~~PRELIMINARY~~ DRAINAGE REPORT
FOR
HONOR CHARTER SCHOOL
LOCATED AT
8250 BENT GRASS MEADOWS DRIVE
PEYTON, EL PASO COUNTY, CO 80831

PCD File No. PPR2615

TAIT & Associates, Inc.
320 North Lincoln Ave
Loveland, Colorado 80537
Phone: (970) 613-1447
Fax: (970) 613-1897

April 2026

Channel Report

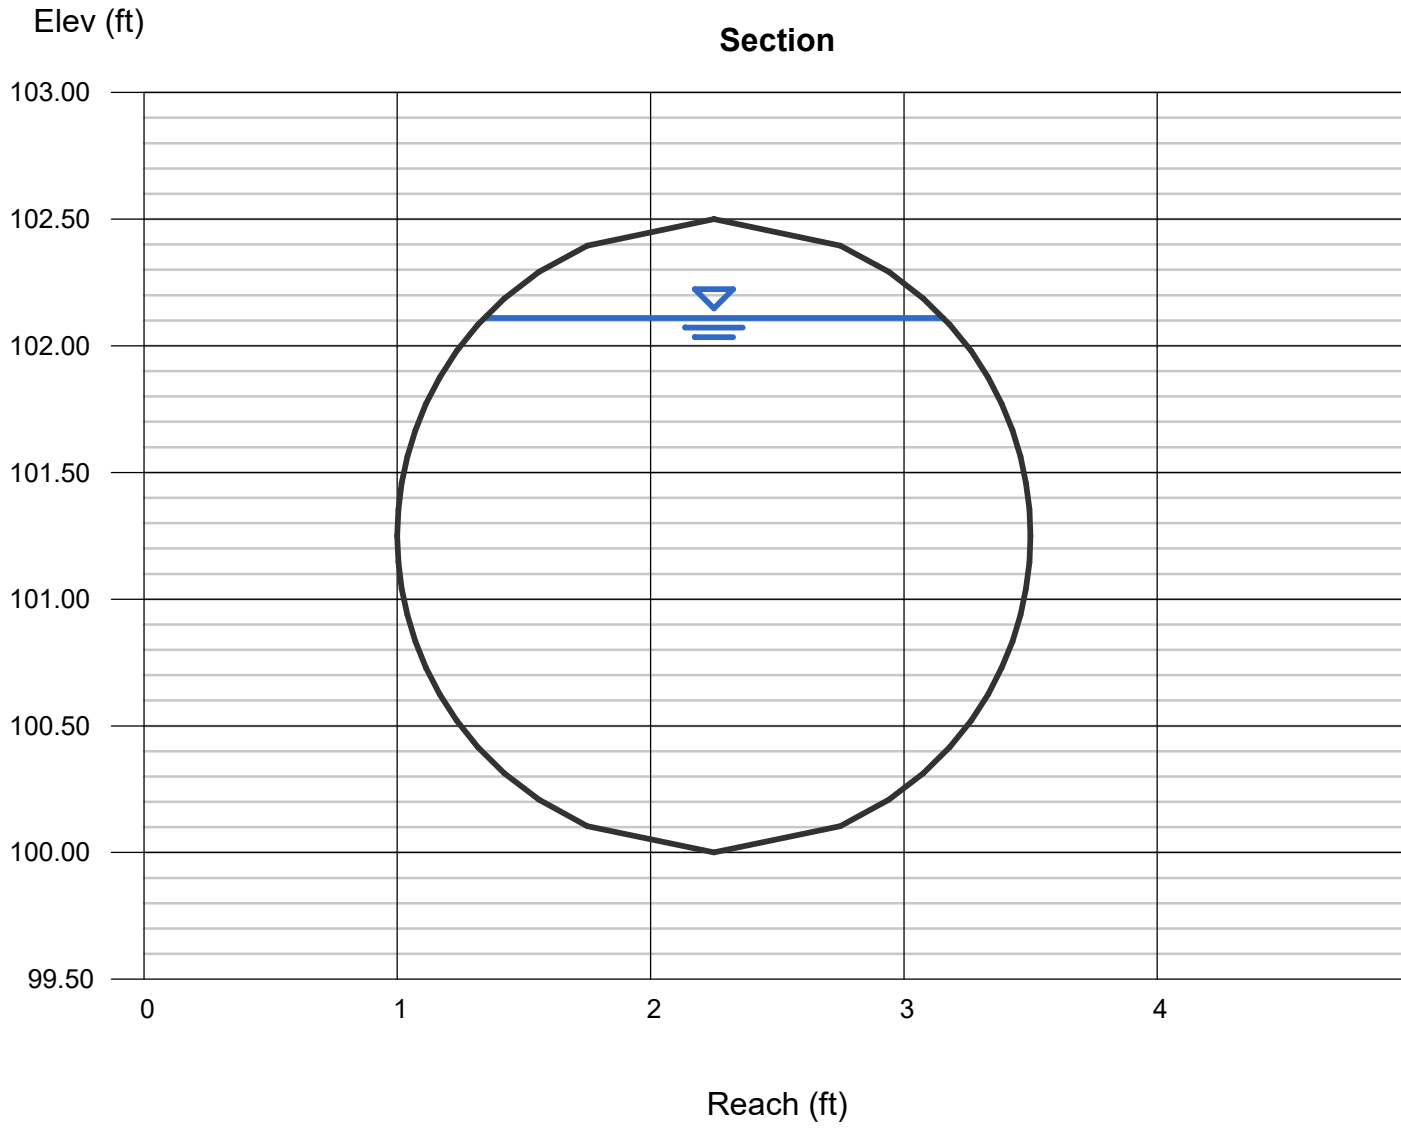
CDs show this culvert as an elliptical culvert, please update
